DEVELOPMENT ASSESSMENT REPORT			
<b>Application No.</b>	DA/2022/0946		
<b>Address</b>	7 Leicester Street, MARRICKVILLE		
<b>Proposal</b>	Demolition of the existing improvements, subdivision of the existing lot into 2 Torrens title allotments and construction of a two storey semi-attached dwelling over basement on each lot and detached outbuilding and swimming pool at the rear of each lot.		
<b>Date of Lodgement</b>	14 November 2022		
<b>Applicant</b>	The Trustee for BLU PRINT FAMILY TRUST		
<b>Owner</b>	Mr Danny Bakopoulos Ms Maria A Ripoll		
<b>Number of Submissions</b>	Four (4)		
<b>Value of works</b>	\$1,246,300.00		
<b>Reason for determination at Planning Panel</b>	Section 4.6 variation (FSR) exceeds 10%		
<b>Main Issues</b>	<ul style="list-style-type: none"> <li>• Subdivision pattern</li> <li>• Non-compliance with the FSR development standard</li> <li>• Streetscape</li> <li>• Solar access</li> </ul>

<b>Recommendation</b>	Refusal		
<b>Attachment A</b>	Reasons for refusal		
<b>Attachment B</b>	Plans of proposed development		
<b>Attachment C</b>	Section 4.6 Exception to Development Standards – Floor Space Ratio		
<b>Attachment D</b>	Draft conditions in the event of approval by P

Figure 1: Proposed subdivision plan  
 Figure 2: Proposed Site Plan

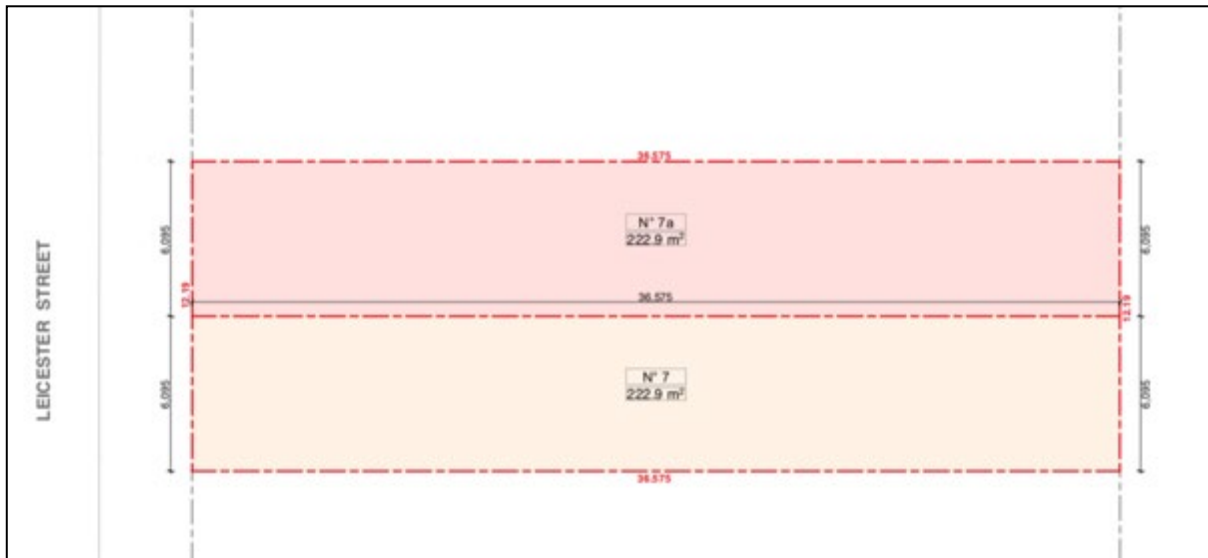
The proposed subdivision pattern would be inconsistent with the prevailing subdivision pattern within the street and as a result, fails to satisfy the relevant requirements within Part 3 of Marrickville DCP 2011 (MDCP) concerning Torrens title subdivision. It is considered that the Section 4.6 exception relied upon by the applicant fails to demonstrate that compliance with the FSR development standard is unreasonable or unnecessary. Furthermore, there are insufficient environmental planning grounds identified to justify contravening the development standard. As a result, the application fails to satisfy Section 4.6(4) within the *Inner West Local Environment Plan 2022 (IWLEP)*.

The above provisions within the DCP sets out two tests for proposed subdivision. The first test relates to consistency with, and retaining the prevailing cadastral pattern of the street. It is important to note that properties in surrounding streets are not part of the streetscape context and therefore are not taken into consideration when determining the prevailing subdivision pattern of the street. The second test is related to the ability of the proposed lots to support dwellings that reasonably comply with the DCP and provide adequate amenity for future occupants and adjoining properties.

Figure 5: Front elevation extract

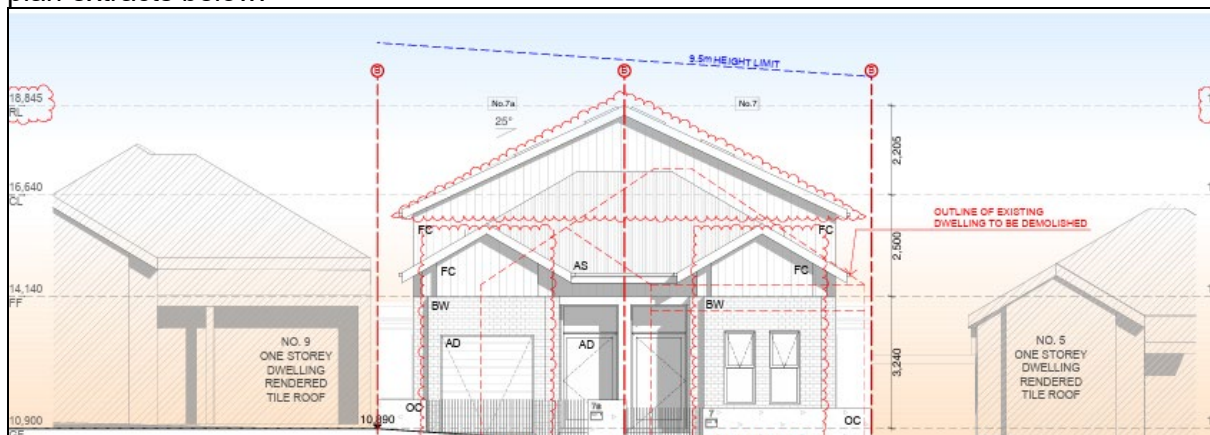
The existing streetscape is typically characterised by dwellings that feature a hipped roof with a gable-ended element fronting the street. The proposed roof form, whilst amended during the assessment of the application, is considered to remain unresolved and fails to achieve an acceptable streetscape outcome having regard to the existing pattern of development within Leicester Street. There is a central portion of the roof on the front

elevation that incorporates a hipped roof, however, it does not read as the dominant element of the design due to the much larger, higher and predominant roof form behind it. Refer to plan extracts below:
